BRUNSWICK STEAM ELECTRIC PLANT, UNIT 1

AMENDMENT TO FACILITY OPERATING LICENSE

Amendment No. 74
License No. DPR-71

ATTACHMENT TO LICENSE AMENDMENT NO. 74

Figure 4.7.5-1

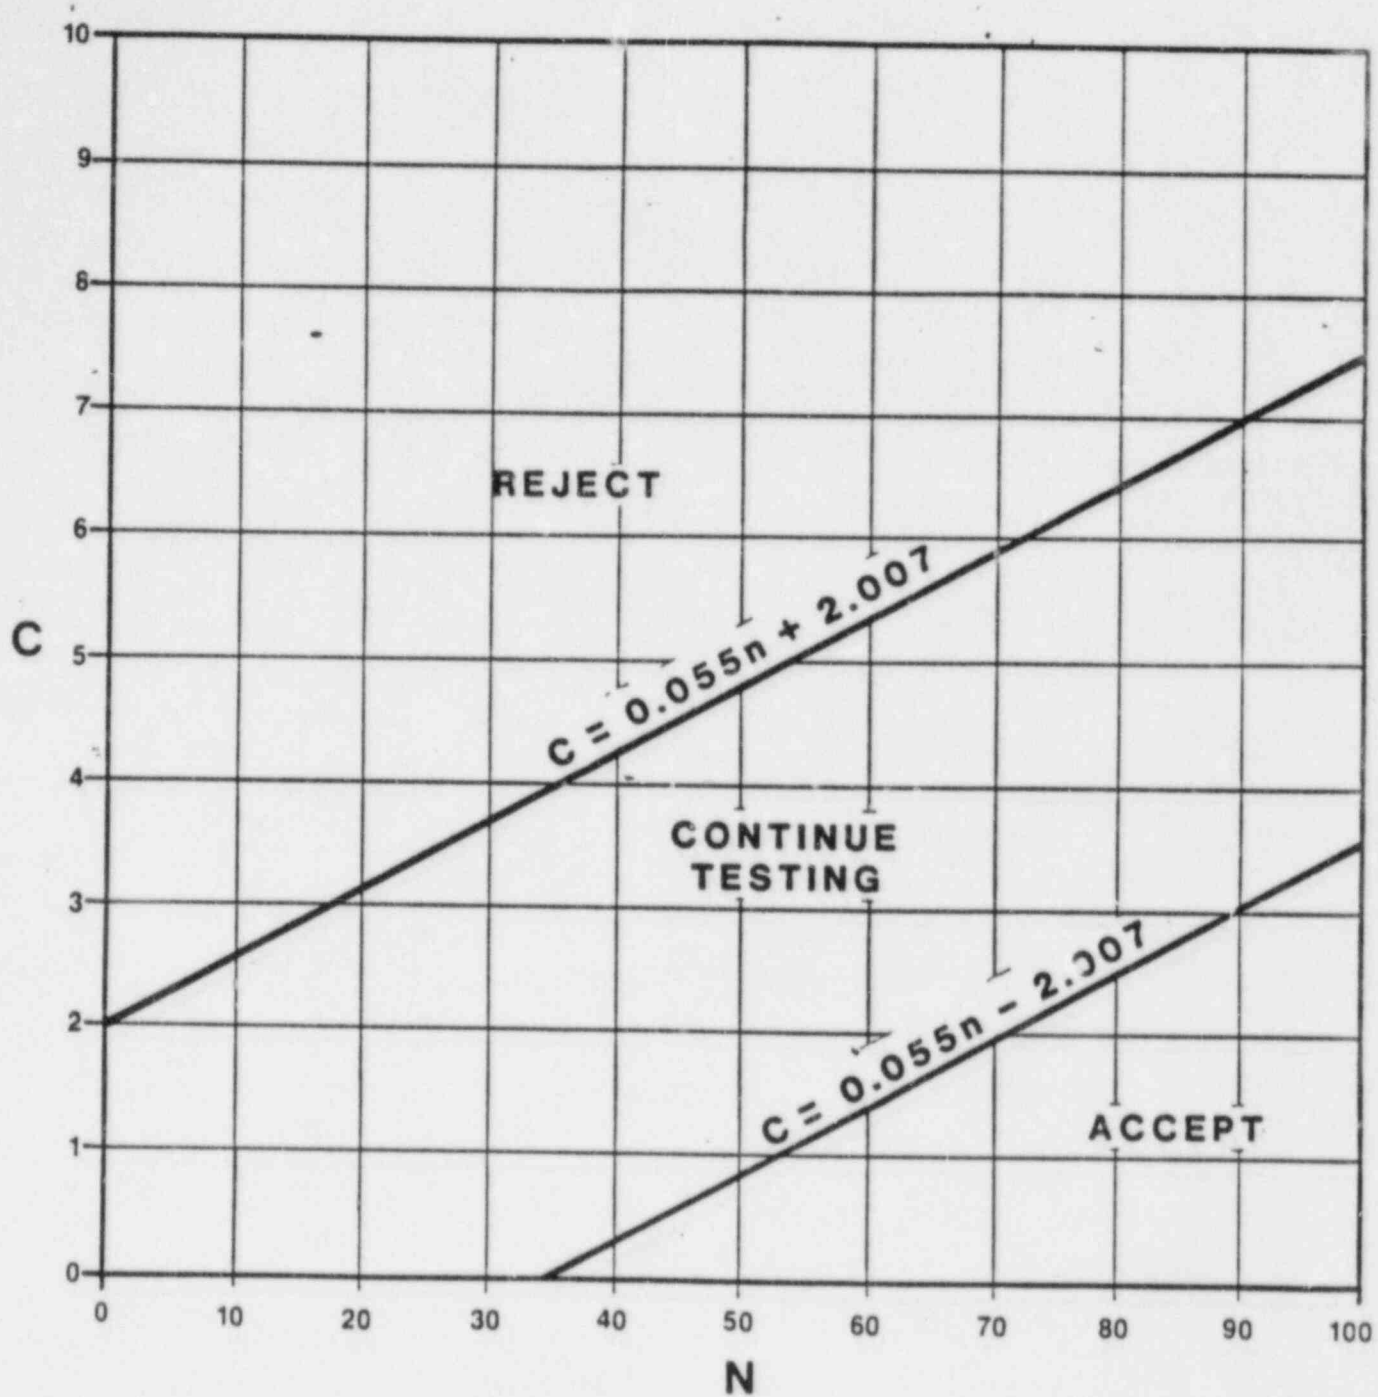
- 2) A representative sample of each type of snubber shall be functionally tested in accordance with Figure 4.7.5-1. "C" is the total number of snubbers of a type found not meeting the acceptance requirements of Specification 4.7.5.f. The cumulative number of snubbers of a type tested is denoted by "N." At the end of each day's testing, the new values of "N" and "C" (previous day's total plus current day's increments) shall be plotted on Figure 4.7.5-1. If at any time the point plotted falls in the "Reject" region all snubbers of that type shall be functionally tested. If at any time the point plotted falls in the "Accept" region, testing of snubbers of that type may be terminated. When the point plotted lies in the "Continue Testing" region, additional snubbers of that type shall be tested until the point falls in the "Accept" region or the "Reject" region, or all the snubbers of that type have been tested. Testing equipment failure during functional testing may invalidate that day's testing and allow that day's testing to resume anew at a later time, providing all snubbers tested with the failed equipment during a day of equipment failure are retested.

Figure 4.7.5-1

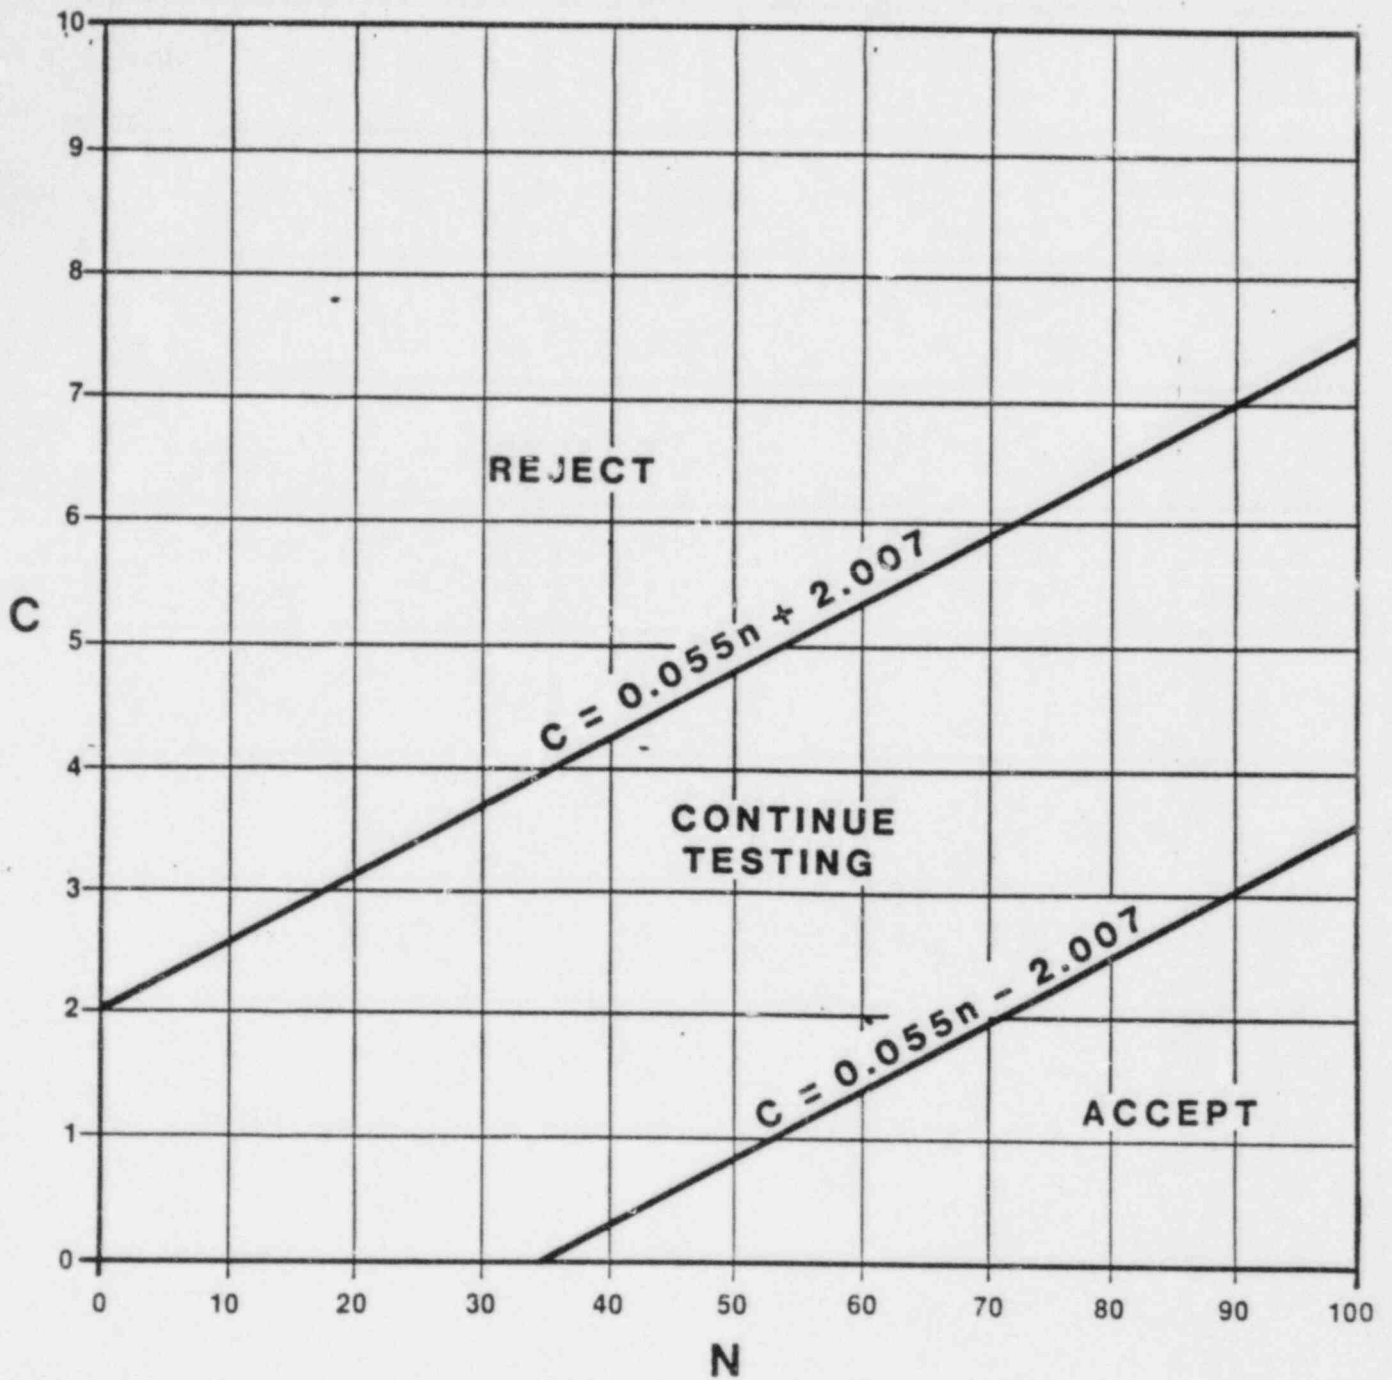
- 2) A representative sample of each type of snubber shall be functionally tested in accordance with Figure 4.7.5-1. "C" is the total number of snubbers of a type found not meeting the acceptance requirements of Specification 4.7.5.f. The cumulative number of snubbers of a type tested is denoted by "N." At the end of each day's testing, the new values of "N" and "C" (previous day's total plus current day's increments) shall be plotted on Figure 4.7.5-1. If at any time the point plotted falls in the "Reject" region all snubbers of that type shall be functionally tested. If at any time the point plotted falls in the "Accept" region, testing of snubbers of that type may be terminated. When the point plotted lies in the "Continue Testing" region, additional snubbers of that type shall be tested until the point falls in the "Accept" region or the "Reject" region, or all the snubbers of that type have been tested. Testing equipment failure during functional testing may invalidate that day's testing and allow that day's testing to resume anew at a later time, providing all snubbers tested with the failed equipment during a day of equipment failure are retested.
